INTERIM ACTION WORK PLAN OU16 SITE IMPROVEMENTS

For:
**FORMER DIAMOND SHAMROCK
PAINESVILLE WORKS SITE**

OCTOBER 2006 (REVISED)

Re: Response to USEPA Comments Letter, TIE016.600.0020.

**FIGURE 2
EXISTING AND PROPOSED CAP IMPROVEMENTS**

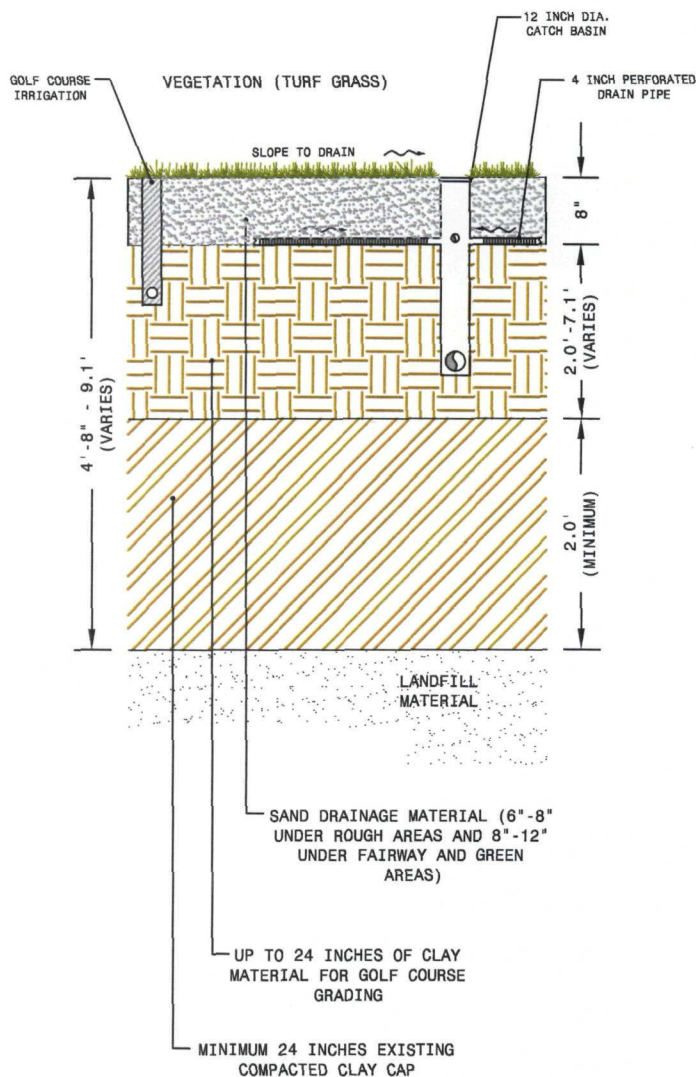
Ohio EPA Comment #6, Figure 2: Will the sand drainage layer, above the clay layer, be adequate to support the turf grass cover or will some additional topsoil be necessary?

Response: *No topsoil will be required to support the turf grass. The sand selected for the drainage layer will be specified such that it will meet the United States Golf Association requirements for fairway construction.*

**FIGURE 3
PROPOSED OU16 LAND USE**

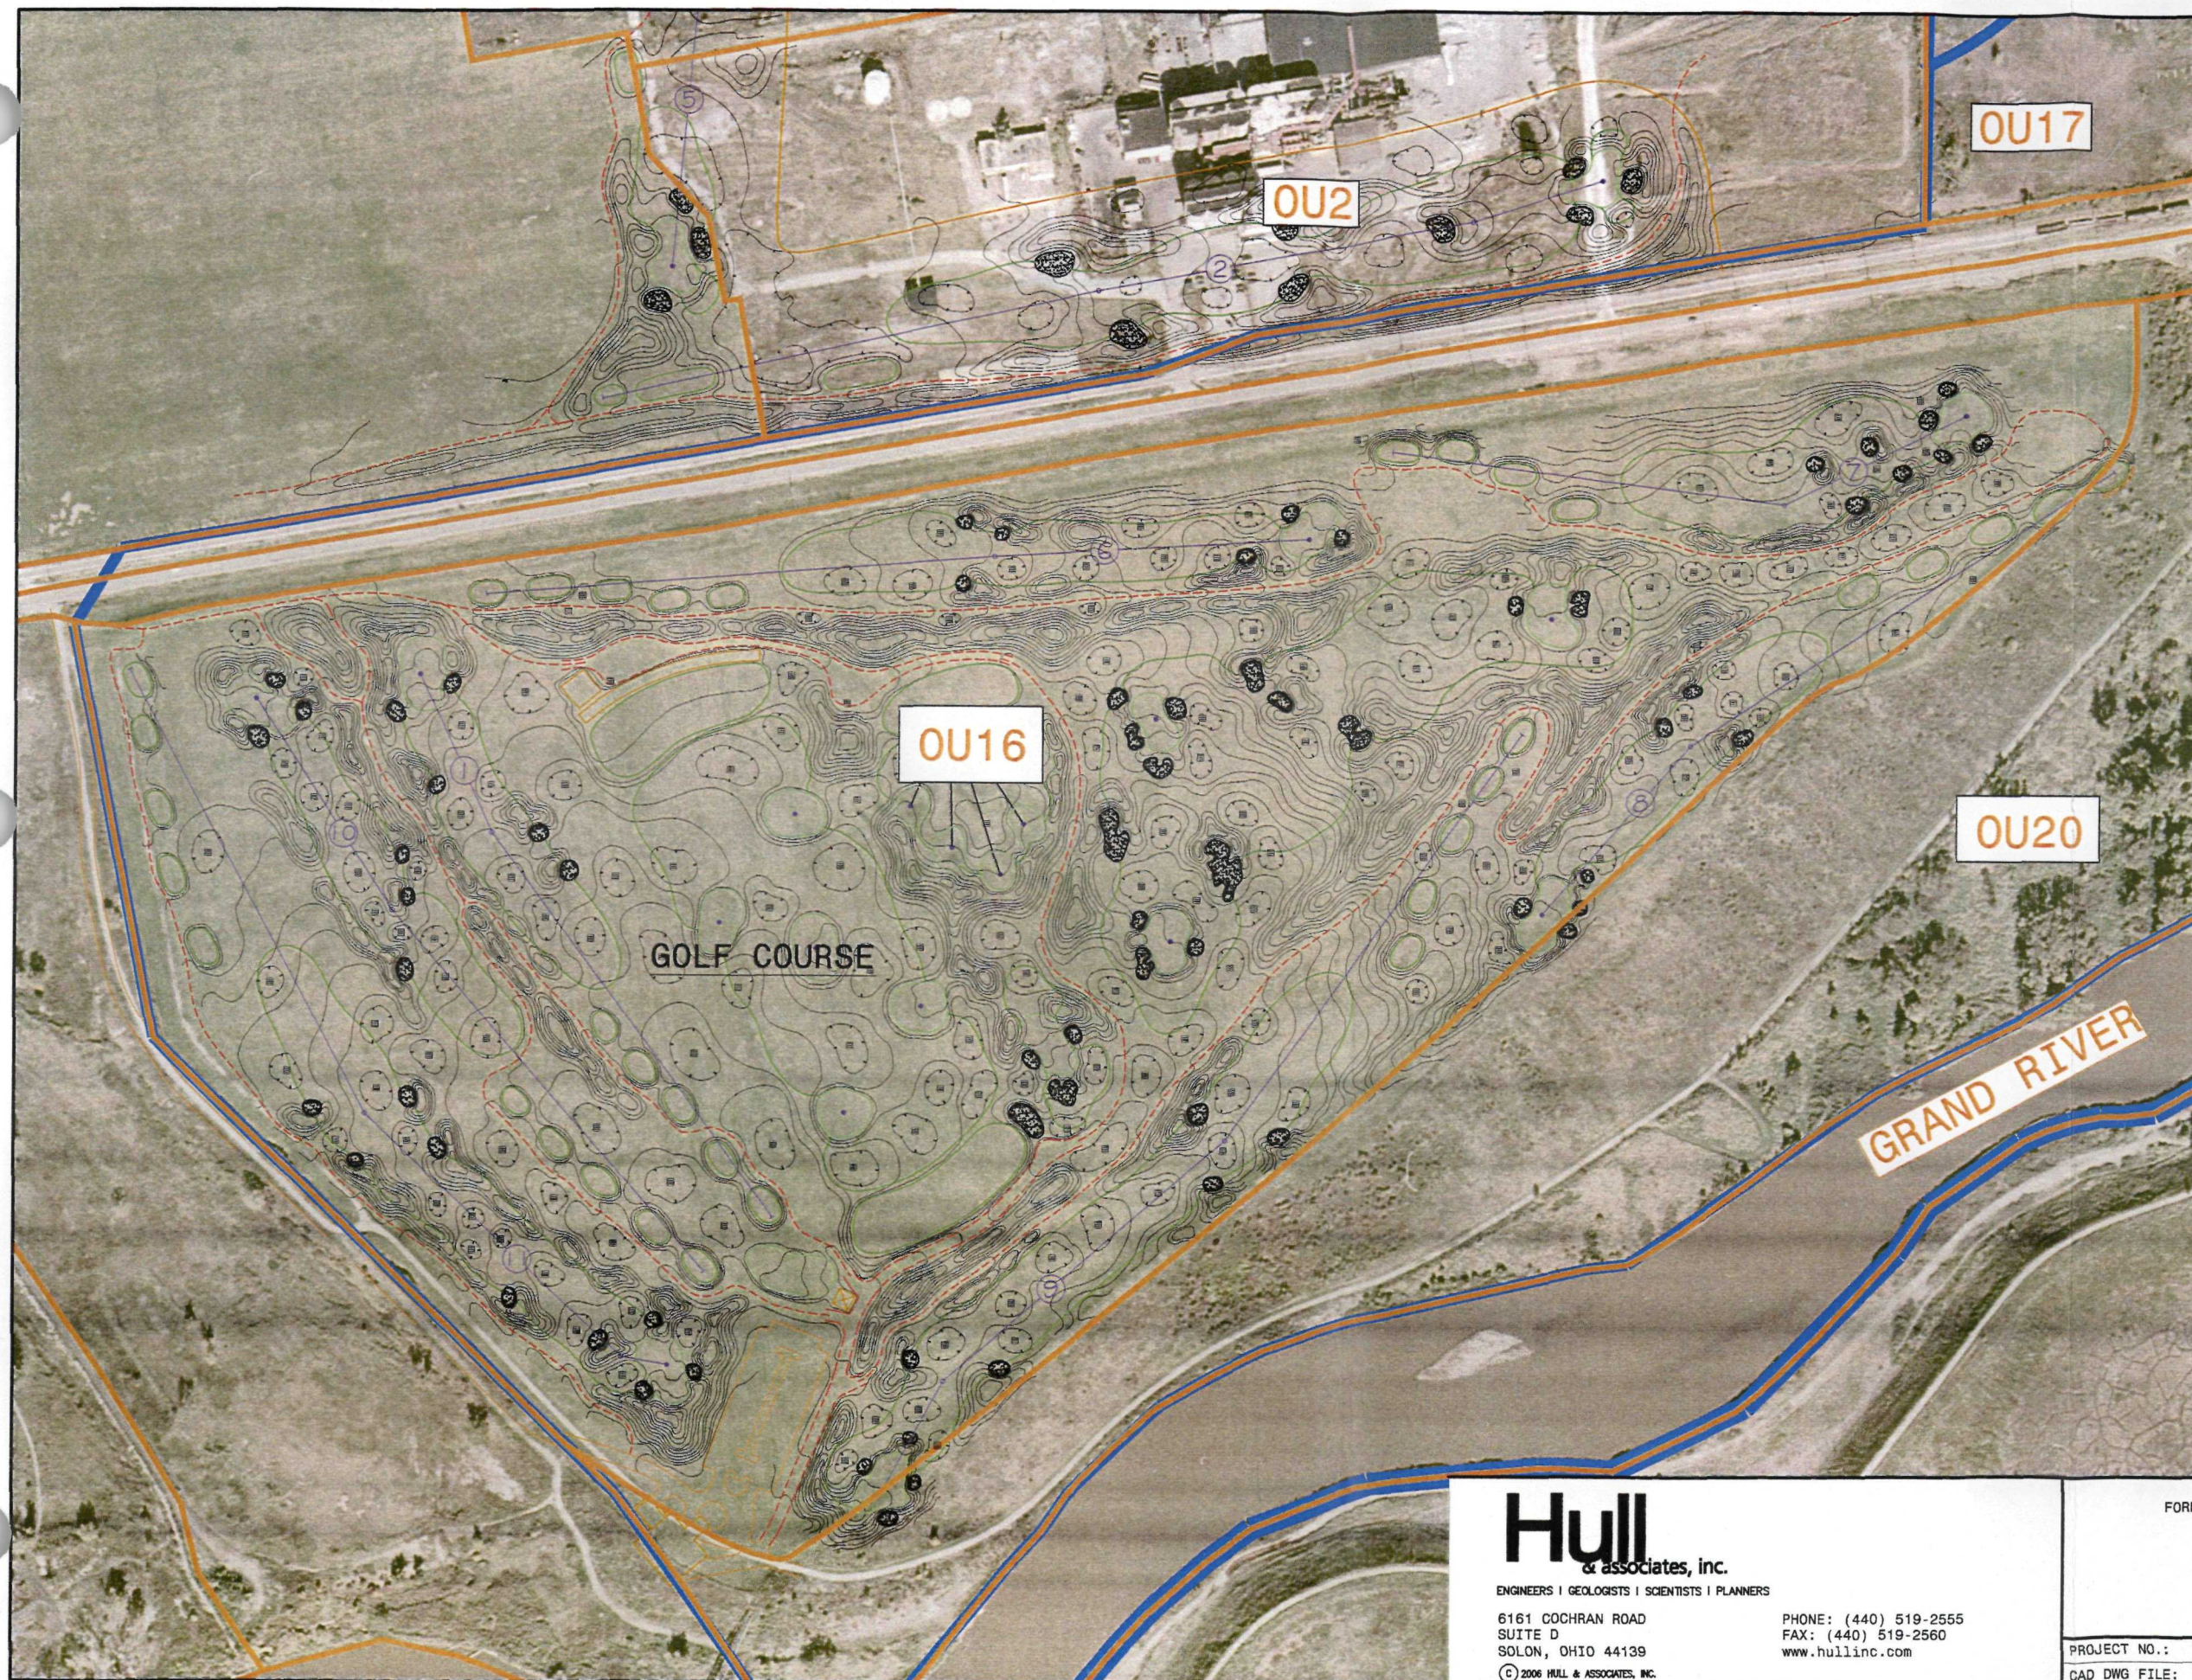
US EPA Comment #3: Figure 3- What are the black blotches? Ponds? Trees? Sand traps? If they are ponds or sand traps they have the ability to alter the recharge of the cap. Please identify these features.

3. Figure 3—what are the black blotches? Ponds? Trees? Sand traps? If they are ponds or sand traps they have the ability to alter the recharge to the cap. Please identify these features.

Response: *The "black blotches" on Figure 3 are sand traps. No ponds or other water hazard will be constructed on the landfill. The sand traps will be constructed entirely above the 24-inch, undisturbed, clay cap. Each sand trap will be drained in a manner similar to the fairways of the golf course to prevent the ponding of water*
